Ultra3000 with SERCOS V13 Firmware Release v1.40

The following enhancements correspond to firmware release v1.40 of the Ultra3000 Digital Servo Drives (with SERCOS interface™) when used with v13 RSLogix™ 5000 software.

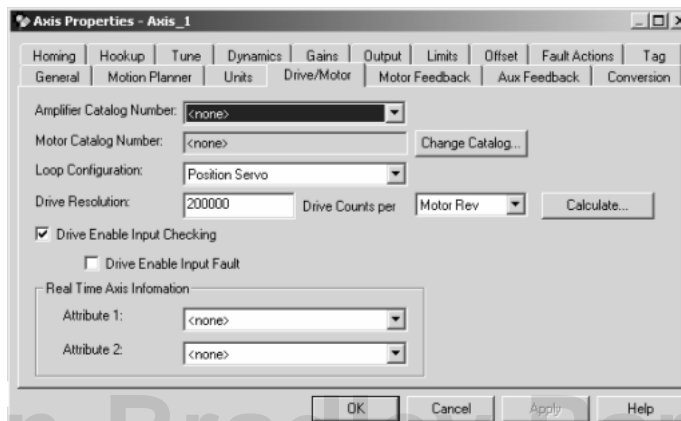
Drive Enable Input Checking

The Drive Enable Input Checking check box has been added to the Axis Properties dialog box (Drive/Motor tab). This new enhancement is used to enable/disable the drive's monitoring of the hardware drive enable input. When checked (default) a hard drive enable input signal is required. When unchecked (disabled), a hard drive enable input signal is *not* required. This eliminates the need to hardwire the input for normal drive operation, and complete drive enable and disable sequencing is provided by the soft drive enable.

Continuous Current Limit

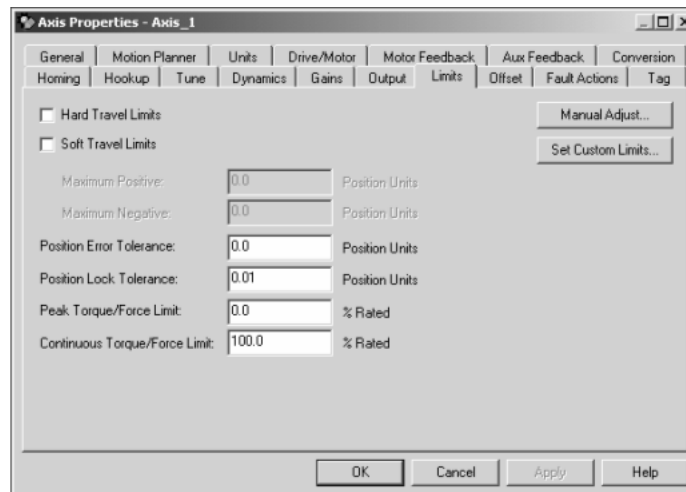
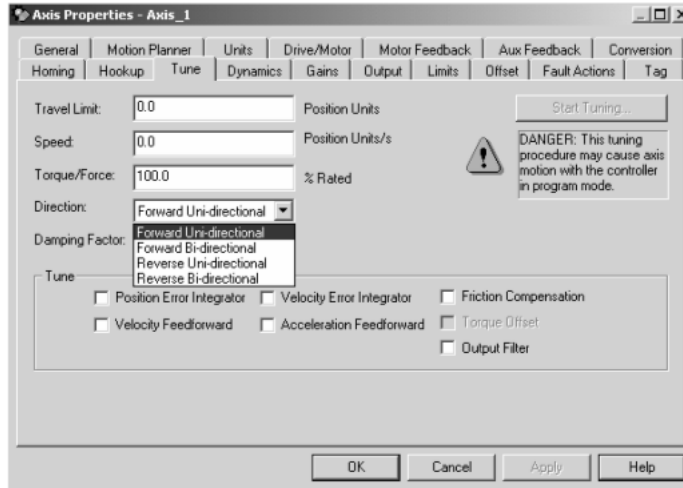
The Continuous Torque/Force Limit field has been added to the Axis Properties dialog box (Limits tab).

In this field, data entry is limited to integer values between 0-200, indicating a 0%-200% range. The drive adjusts the motor's continuous current rating based on this value.

A custom motor database with a suitable continuous torque/force limit is required to use this feature above the 100% setting. The standard motor database shipped with the RSLogix 5000 software restricts the Continuous Torque/Force Limit to 100%.

Note: Increasing or decreasing the motor continuous current rating does not change the drive's continuous current limiting.
